DESIGN REVIEW BOARD RECOMMENDATION MEETING SEATTLE HOTEL on 2nd & Stewart Street

Project Number : 3019290

February 2, 2016

Date Of Meeting: July 28, 2015
 Project Number: 3019290
 Site Zone: Dmc 240/290-400

DEPARTURE #1 – BLANK FACADE DIAGRAM

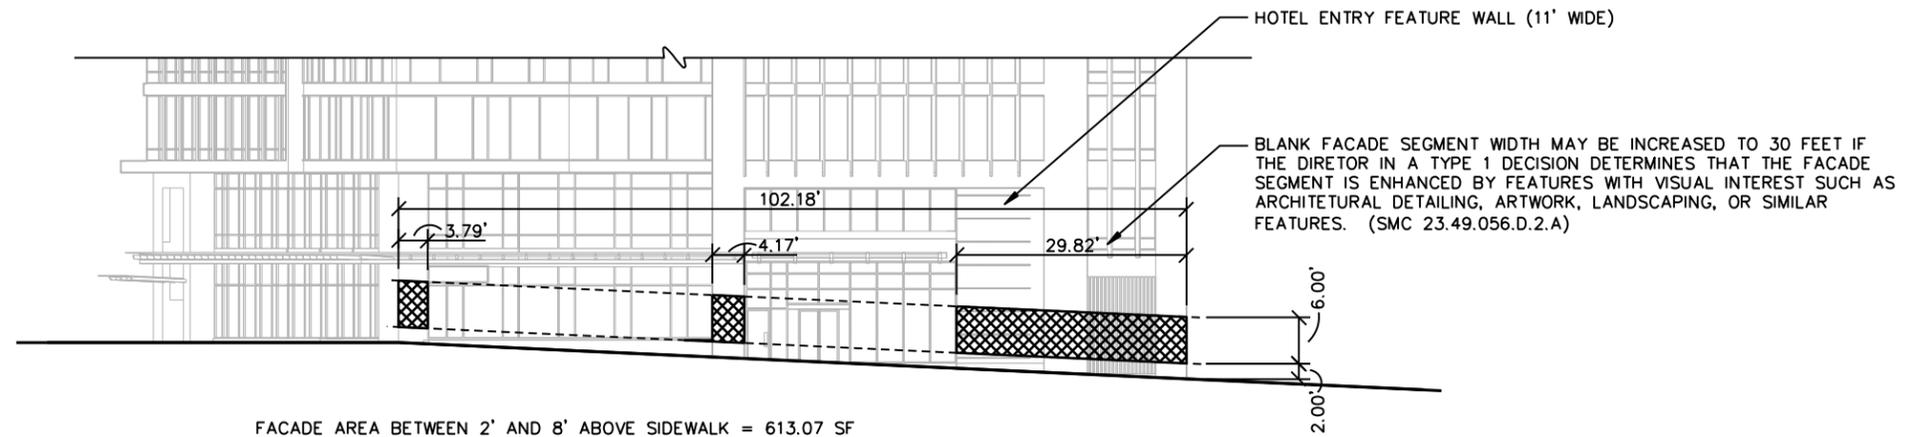
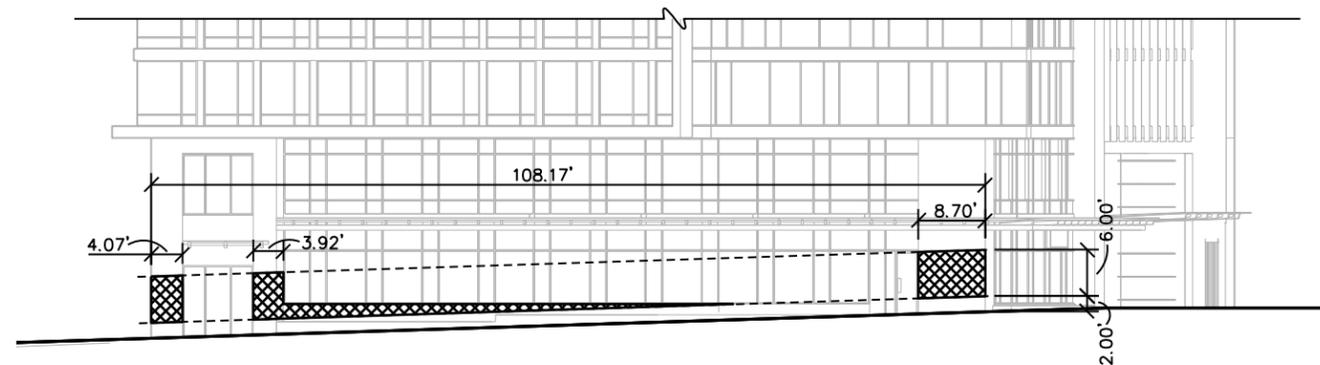
Design Departure Requests				
	Development Standard	Code Requirement	Departure Request	Justification
# 1	SMC 23.49.056.D.2 BLANK FAÇADE LIMITS (Refer to page 38 for further information)	Blank facades shall be no more than 15' wide. Blank façade segment width may be increased to 30' if the Director in a Type 1 decision determines that the façade segment is enhanced by features with visual interest such as architectural detailing, artwork, landscaping or similar features.	Request to increase the width of blank façade up to 30' along Second Street at the southernmost portion of the site. This increase to 30' will still keep the blank façade length under the maximum allowable of 40% of the frontage.	The southernmost corner of the hotel site along Second Avenue is occupied by the subterranean garage fresh air intake louver approved under DPD #3016586 which occupies approximately 15' of the facade. Adjacent to this is the angled feature wall leading from the sidewalk to the entry of the hotel. These two elements combined total a blank faced of 29.82'. The current design integrates the louver into the overall composition of the facade, recessing the louver and cladding the surround in stone, consistent with the larger elements of the proposed façade up to level 5. Directly adjacent to the louver stone cladding is an angled feature wall, intended to create a break and visual interest from the building line along Second. This feature wall will be clad in a stone material and incorporate lighting elements that enhance the visual interest of this portion of the sidewalk for passersby while creating a dramatic architectural entry marker for the hotel guest. Through the use of high quality materials, the attention to detail, and enhanced articulation at this area of the façade, we feel the proposed design meets the intent afforded under the Director's decision to allow an increase in blank façade up to 30'.

FACADE AREA BETWEEN 2' AND 8' ABOVE SIDEWALK = 613.07 SF

OPAQUE FACADE = 226.95 SF (37.01%)

PROPOSED: 37.01% BLANK FACADE
 REQUIRED: 40% MAXIMUM (SMC 23.49.056.D.2)

FACADE AREA BETWEEN 2' AND 8' ABOVE SIDEWALK = 646.59 SF

OPAQUE FACADE = 154.98 SF (23.97%)

PROPOSED: 23.97% BLANK FACADE
 REQUIRED: 40% MAXIMUM (SMC 23.49.056.D.2)

# 3	SMC 23.54.035 TABLE A LOADING BERTH QUANTITY (Refer to page 38 for further information)	Per Table A, a building with low demand use and a gross square footage between 160,001 sf and 264,000 sf requires a total of three loading berths.	Reduce the requirement from 3 to 1 loading berth.	The following operational statement in favor of the reduction has been developed by the operator for the hotel: We are able to operate with one loading dock effectively, by managing the deliveries. We have done this at other urban locations (larger hotels) with much success. Having specific day of week and time of day deliveries for our vendors will allow for a simplified and organized approach. As an example, our main Food purveyors will deliver on Monday, Wednesday and Fridays between 7 – 8 AM. Guest Supply vendor will deliver Wednesday at 10AM, ETC. We will have a detailed schedule of all vendors and the delivery time. If they do not deliver at their scheduled time, we will refuse delivery, or reschedule at an open slot. With the position of Purchasing/Receiving Manager dedicated to overseeing all ordering and deliveries, this has proven to be an effective process in maintaining an organized and streamlined process for managing our inventories as well as the delivery of them.

PROPOSED: 1 LOADING BERTH
 REQUIRED: 3 LOADING BERTHS (SMC 23.54.035 TABLE A) FOR LOW DEMAND USE BETWEEN 160,001 SF TO 264,000 SF.

DEPARTURE #2 – STREET SETBACK REQUIREMENT – FACADE SETBACK LIMITS

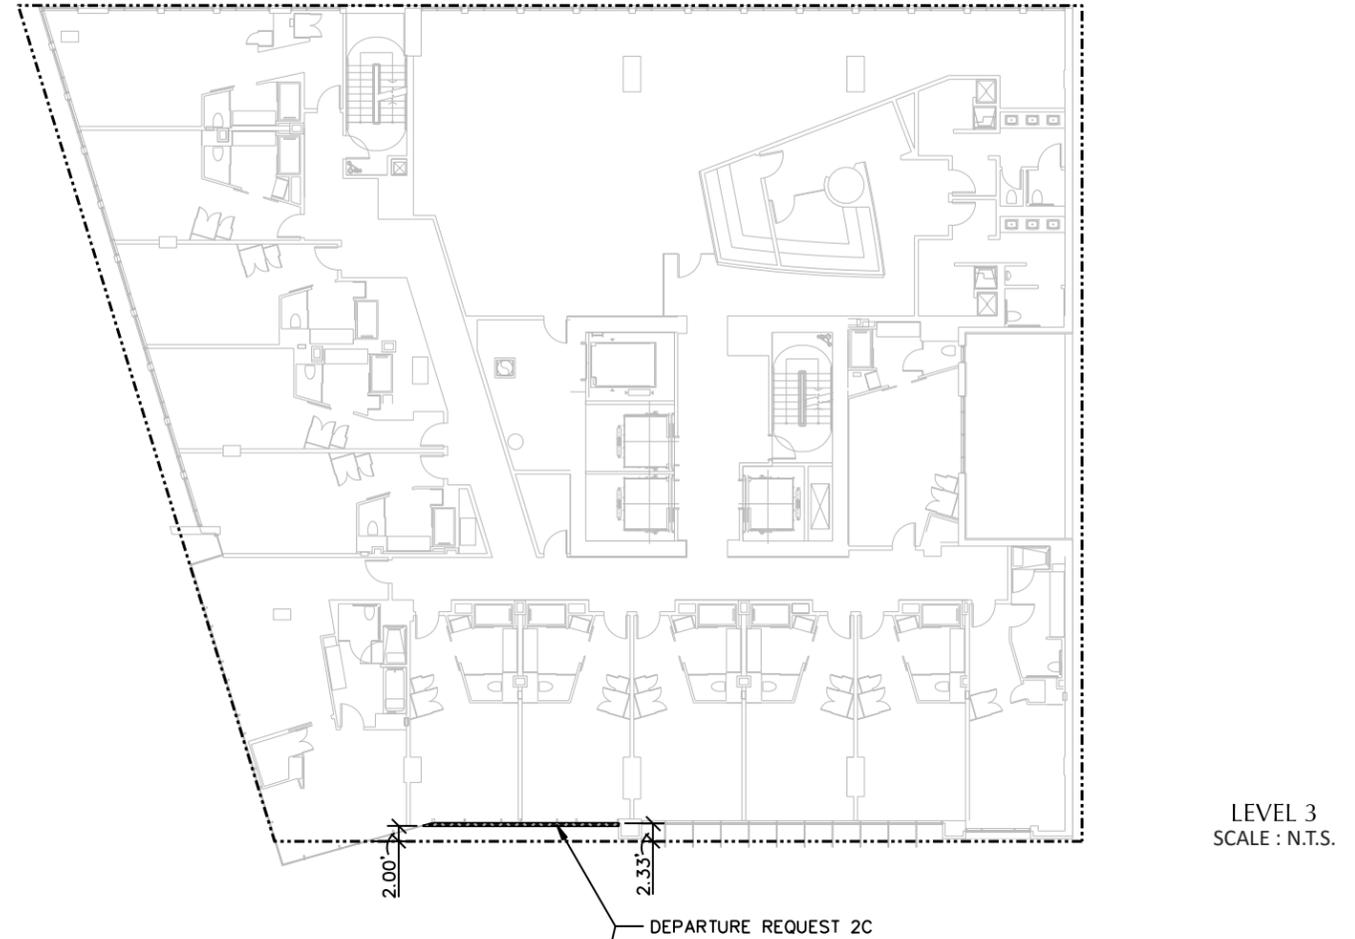
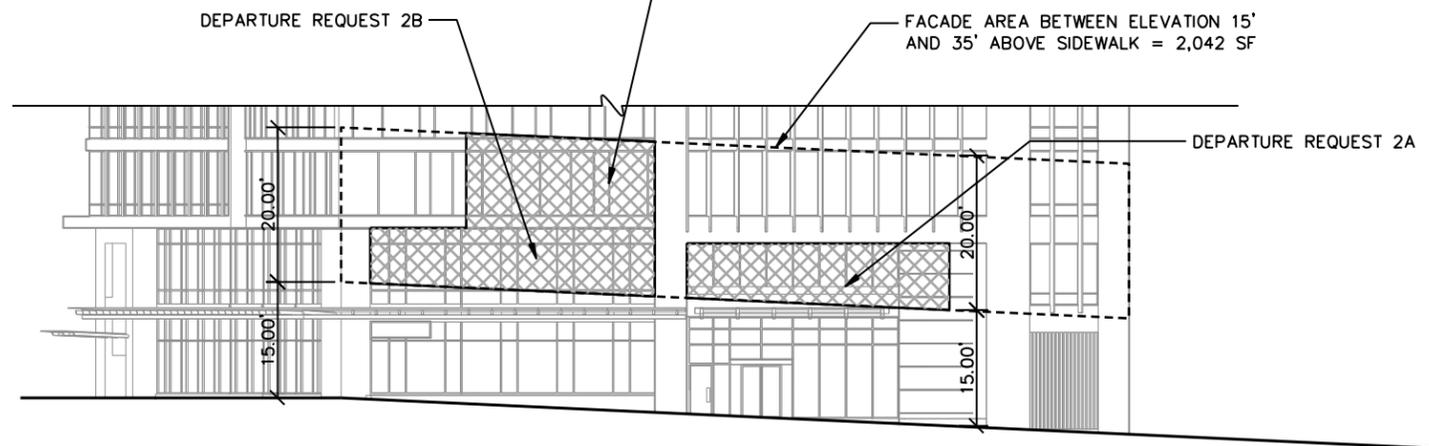
# 2A	SMC 23.49.056.B.1.b.2.b.iii FAÇADE SETBACK LIMITS (Refer to page 39 for further information)	SMC 23.49.056.B.1.b.2.b.iii Between 15' and 35' above the sidewalk, no setback deeper than 2 feet shall be wider than 20'.	Allow setbacks deeper than 2' along Second to exceed the allowable 20' at the entry to the hotel to be 26.25' wide as shown in the diagrams on page 39.	Due to the steep sidewalk slopes along Second, the hotel entrance has been setback off the property line the maximum allowable 10' to allow for the necessary slopes and warping of sidewalk on our property to present a level approach to the entry for guests and those confined to wheelchairs. This proposal requests to widen this setback more than the allowable 20' to 26.25' in order to ease potential guest congestion at the front door during check-in and check-out periods. The resulting extra width at 26.25' has the architectural benefit of allowing the expression of the volume of space on the inside of the hotel lobby which is two floors high to be expressed on the outside of the building, creating the look of a more generous entry portal to the hotel and allowing more visual connection from the sidewalk into the hotel lobby.

# 2B	SMC 23.49.056.B.1.b.2.b.iii FAÇADE SETBACK LIMITS (Refer to page 39 for further information)	SMC 23.49.056.B.1.b.2.b.iii Between 15' and 35' above the sidewalk, no setback deeper than 2 feet shall be wider than 20'.	Allow setbacks deeper than 2' along Second to exceed the allowable 20' above the restaurant at the second floor prefunction area to be 39' wide as shown in the diagrams on page 39. There is also a related request to allow the setback to be 2.33' in lieu of 2' at level 3 also as shown on page 39.	This 39' wide setback is not as deep as the setback at the entry, only 3.5' in lieu of the allowable 2' setback, however, this additional setback request is critical to the architectural concept of the shifted building mass above level 2 that relates to the shift in street grid along Second. Reducing this setback back to the allowable 2' will minimize the building overhang effect as well as the desired effect of the shift in façade plane. We could compensate by pulling the entire façade that is parallel to Second above level two forward towards the street, but this also has an even stronger effect of minimizing the shift in plane along Second because the angled portion of the tower cannot be pulled forward as it will exceed the current limits of the allowable overhang indicated on page 39.

PROPOSED: REDUCE FACADE RETURN TO WITHIN 2 FEET OF THE STREET LOT LINE BETWEEN EACH SETBACK AREA (AS SHOWN 3.79' AND 4.17')

TWO FACADE AREAS WITH SETBACK DEEPER THAN 2 FEET BUT LESS THAN 10 FEET ARE WIDER THAN 20 FEET (AS SHOWN 39.00' & 26.50')

PROPOSED: AREA SET BACK MORE THAN 2' FROM PROPERTY LINE BETWEEN ELEVATION 15' AND 35' = 849 SF (849 SF / 2,042 SF = 41.6% OF FACADE AREA)
